**Before the
FEDERAL COMMUNICATIONS COMMISSION
Washington, D.C. 20554**

In the Matter of)	
)	
Revision of Part 15 of the Commission's Rules)	ET Docket 98-153
Regarding Ultra-Wideband Transmission)	
Systems)

SPRINT REPLY COMMENTS

August 14, 2002

Figure 1. The FCC's indoor UWB mask. The dotted green line suggests how real UWB signals will roll off below 3.1 GHz.

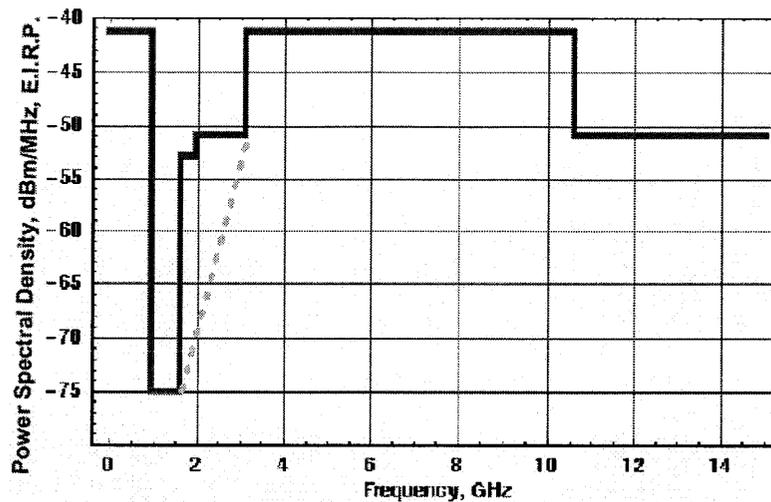
Sprint demonstrated in its Petition that the Commission's failure protect licensed PCS services is inexplicable because UWB emissions in the PCS band would be spurious emissions only – meaning they are not necessary for UWB devices to perform their designed functions.³⁰ TDC agrees with this Sprint point, describing its UWB emissions in the PCS band as “useless signals.”³¹ In fact, TDC acknowledges that the Commission could tighten the indoor UWB emissions limit by about 15 dB without having any negative impact on UWB devices. This is demonstrated by Figure 1 in TDC's Opposition, which Sprint reproduces below:

As can be seen, the dotted line, which according to TDC represents the spectral rolloff of an actual UWB signal, crosses the 2 GHz PCS line at a level of about -68 dBm/MHz and drops rapidly as frequency decreases. This means that the indoor UWB emission limit in the PCS band (currently -53.3 dBm/MHz) could be reduced by about 15 dB (to -68 dBm) without impacting UWB designs in any way.

unsupported assertion that some of its products might be impaired by more rigorous limits on UWB spurious emissions is contradicted by the data TDC provided in Figure 1 above.

In summary, based on the evidence TDC submitted in its Opposition, the Commission should establish an indoor UWB emissions level in the PCS band of -68 dBm. It is noteworthy that -68 dBm is the indoor level Sprint recommended in its Reconsideration Petition.³⁴
